Site Audit Report for Stage 2 Audit Area 2 (Proposed Lots 59, 60, 63 and road) - Remediation and Validation Program

Clyde Western Area Remediation Project

Viva Energy Australia Pty Ltd

14 April 2022

F10

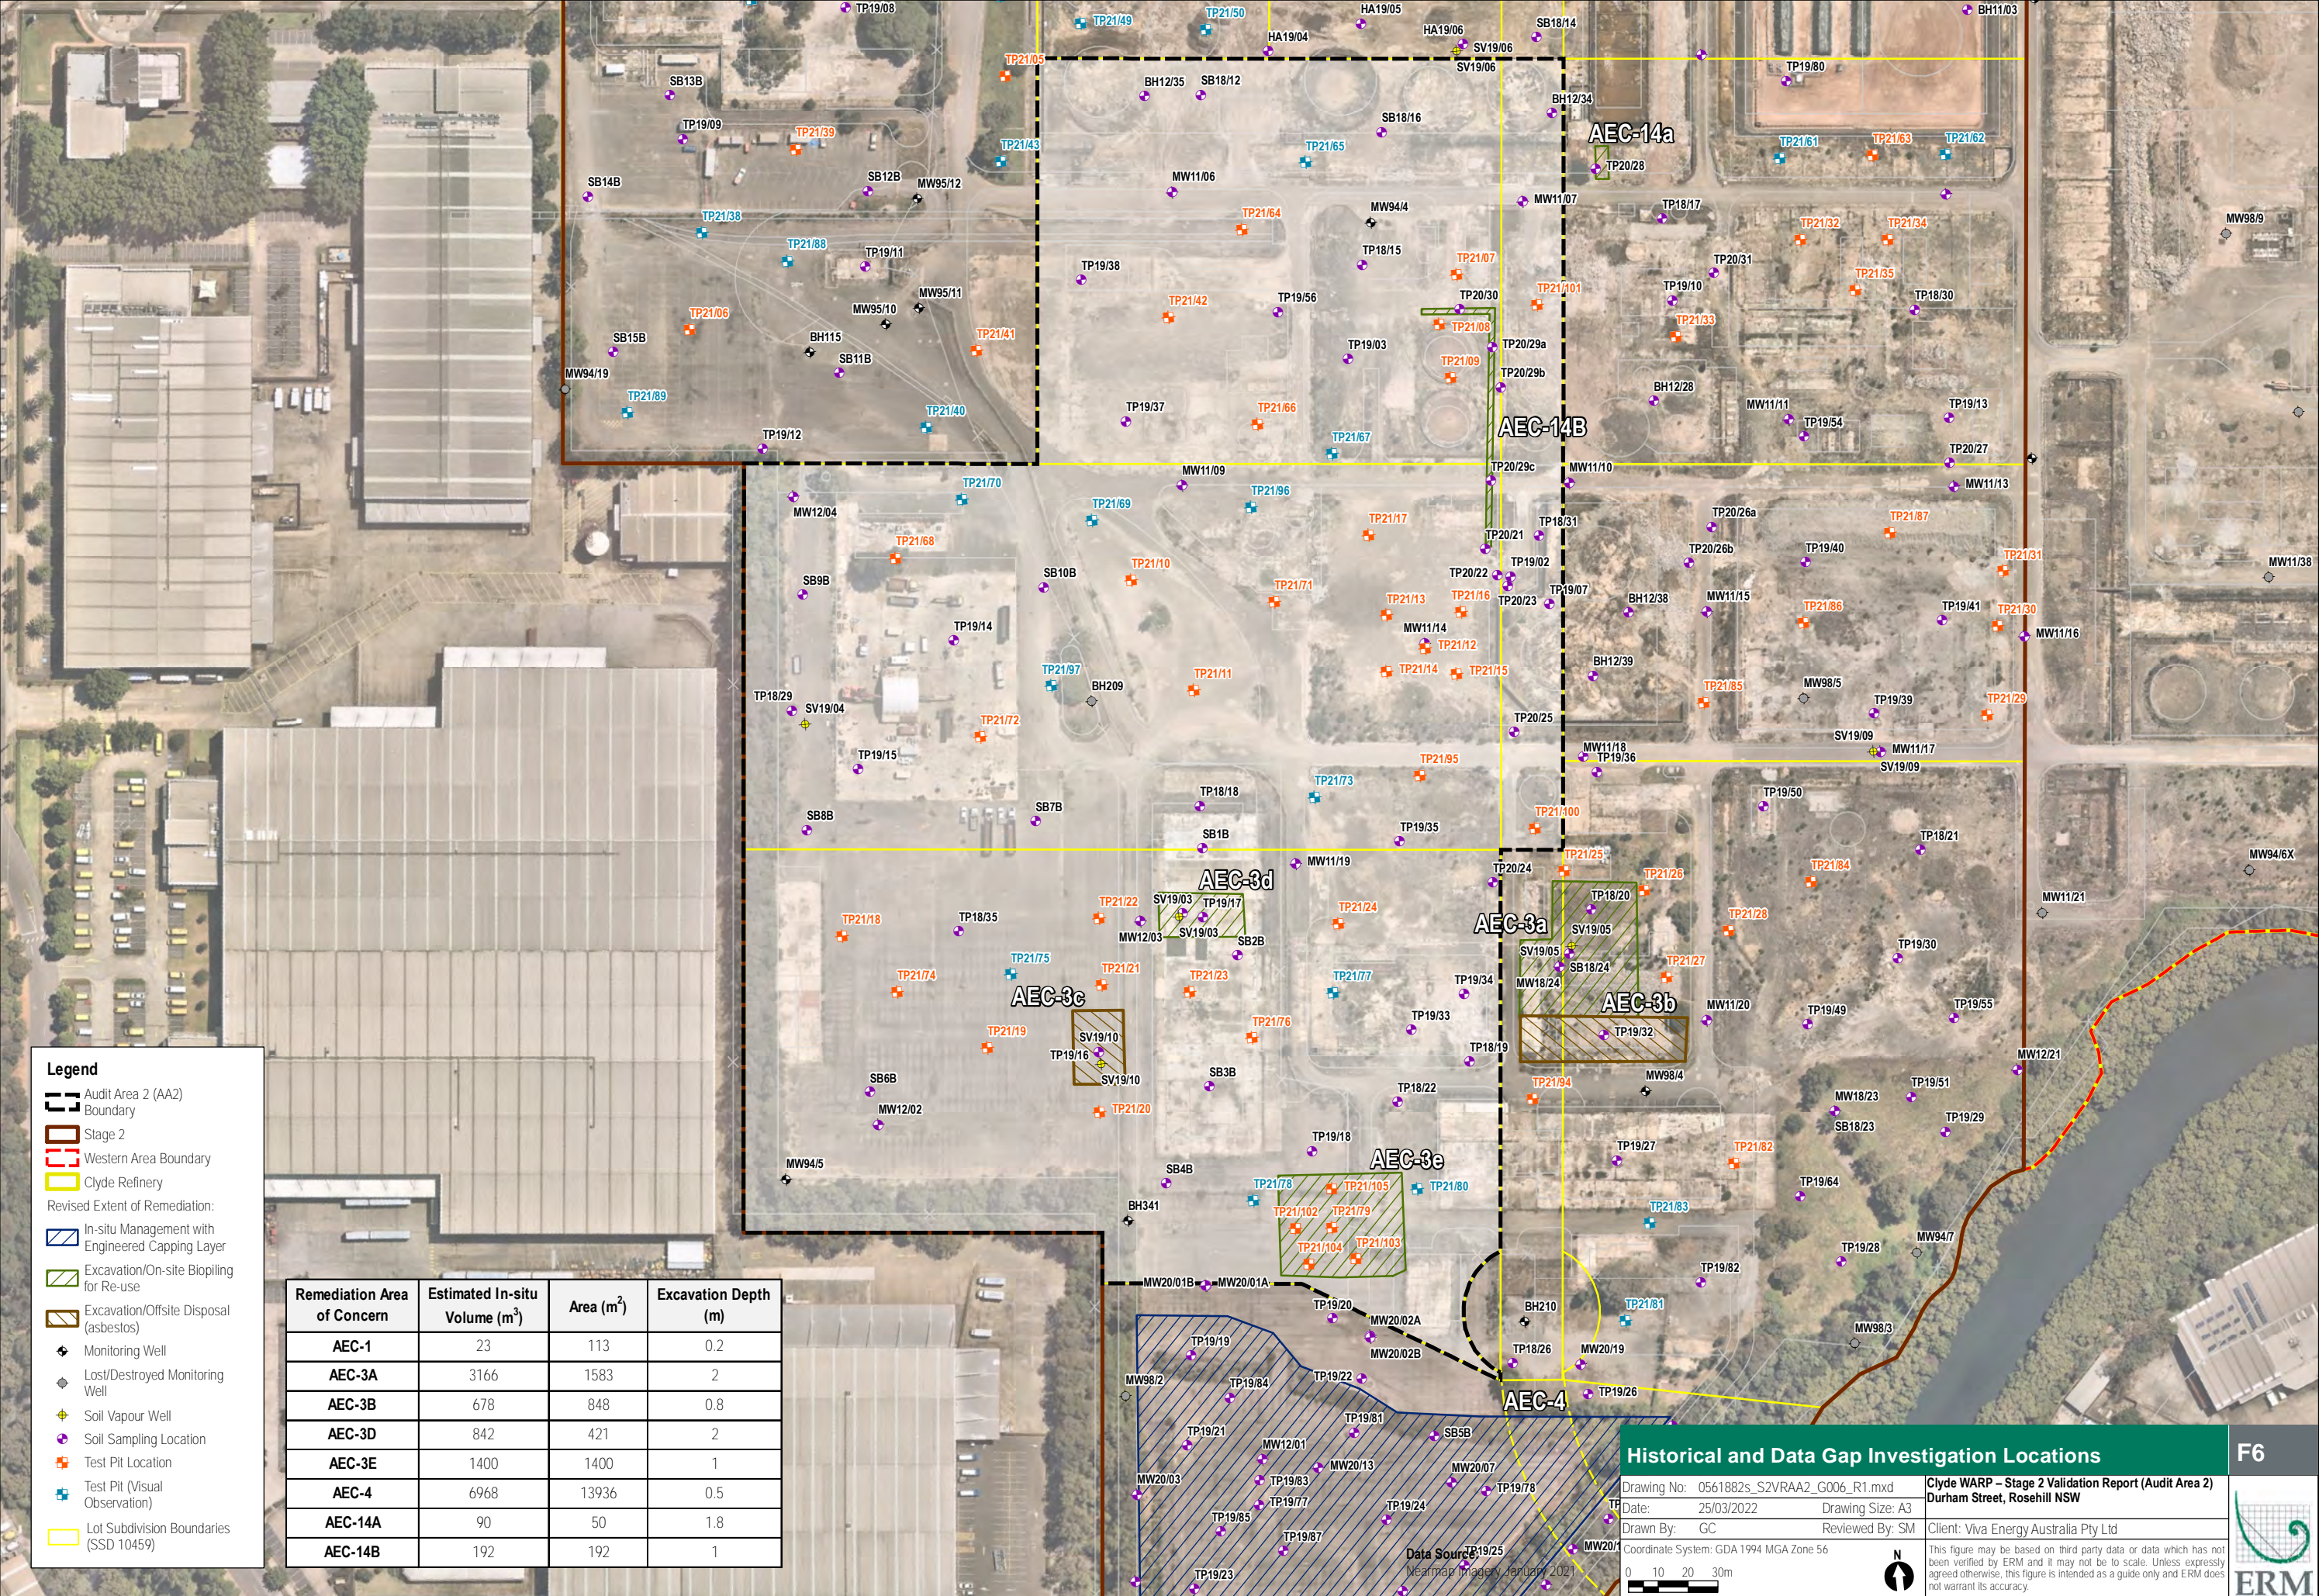
NA	Figure F10	1 -The lots in Figure F10 should be shown. 2 -The validation sampling should be presented for all AECs, not only AEC-3d. 3 - The conduit containing asbestos within AEC3d should be presented. 4 - The depth of LNAPL within soil should be presented. 5 -The depth of soils where expected aesthetic issues may be encountered should be presented. 6 - Areas where asbestos could be found, should be presented.	Comments 1-6 to be addressed via figure amendment (reproduction of Figure F2 from LTEMP 2 - Select locations for AEC-3D shown only as TRH management limit exceedances identified in these locations at the lateral extent of location. Validation sample locations have been shown on other figures. No amendment proposed here.	✓
--	----	------------	---	--	---
